PART 573 Defect and Noncompliance Report

Make:	Vermeer	Model Years Involved:	2012-2013	
Model(s):	HG6000TX			
Production Dates:	Beginning:	7/20/2012	Ending:	8/21/2012
VIN Range:	Beginning:	1VR2390A8C1001005	Ending:	1VR2390A1D1001008
Vehicle Type:	Trailer – Dolly Kingpin Option on Horizontal Grinder

- Model HG6000TX horizontal grinder units, S/N 1005-1008, were equipped with an optional Weldment-Hitch Assembly, Item number 163701081 (Exhibit A) that the kingpin would be attached to. This optional Weldment-Hitch Assembly is used in conjunction with the Vermeer DT6 Dolly Transport to convert a tracked horizontal grinder into a trailer. The P/N 163701088 Plate-Hitch Lower Side Bends (Exhibit B) was manufactured without the machining feature of 10.30" diameter by .13" deep for the kingpin.

WPS 3-G-A100 CENTER PART IN CUT-OUT 300 F PREHEAT REQ'D		APPROXIMATE WEIGHT 766.0586C LB.
WELDMENT-HITCH ASSEMBLY		
163701081	DATE:	VERMEER

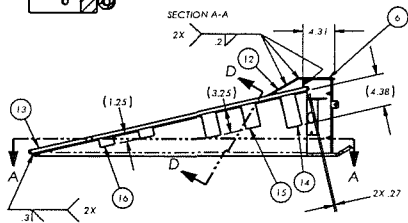
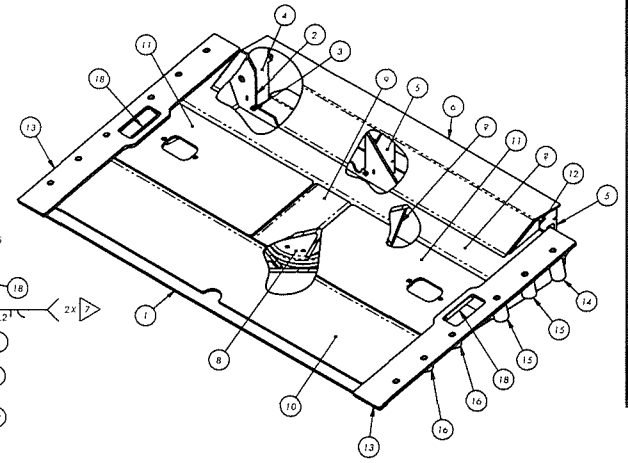
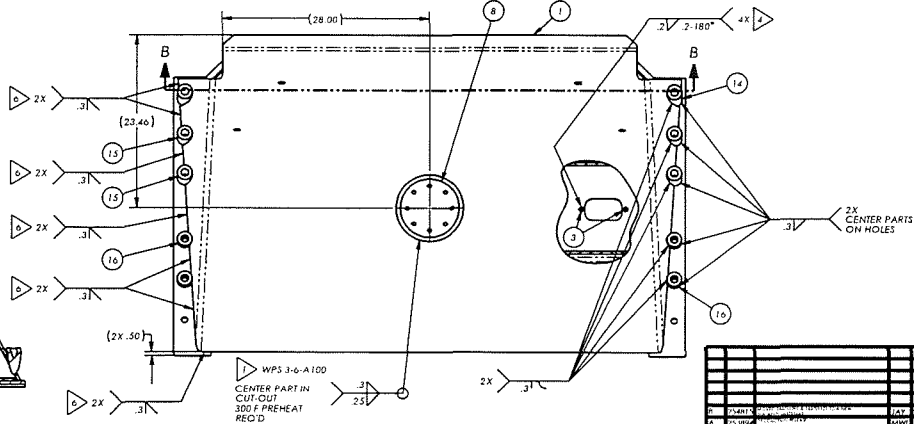
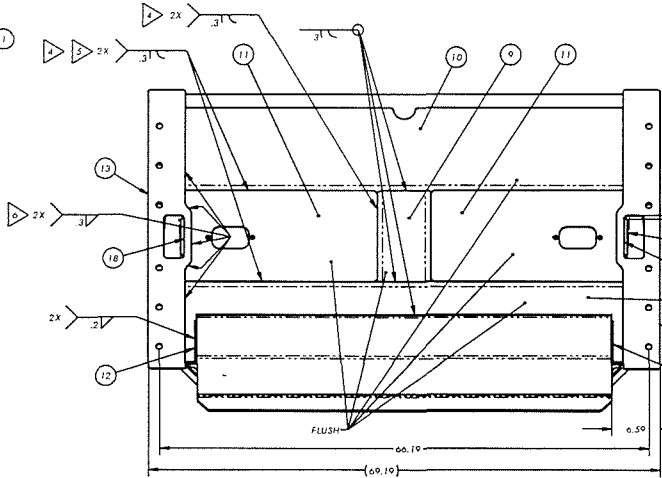
7-SEPT-2012 **First notification** – Vermeer manufacturing notified Environmental Engineering Manger about a potential issue with the Weldment-Hitch Assembly 163701081. The machining feature that dictates the height of the trailer kingpin on P/N 163701088 Plate-Hitch Lower Side Bends may not have been included on previous manufactured parts.

- Provide correctly manufactured P/N 163701081 to replace incorrectly manufactured Weldment-Hitch Assembly.

- Dealers will be instructed to remove the incorrectly manufactured Weldment-Hitch Assembly P/N 163701081 and replace with a correctly manufactured part.
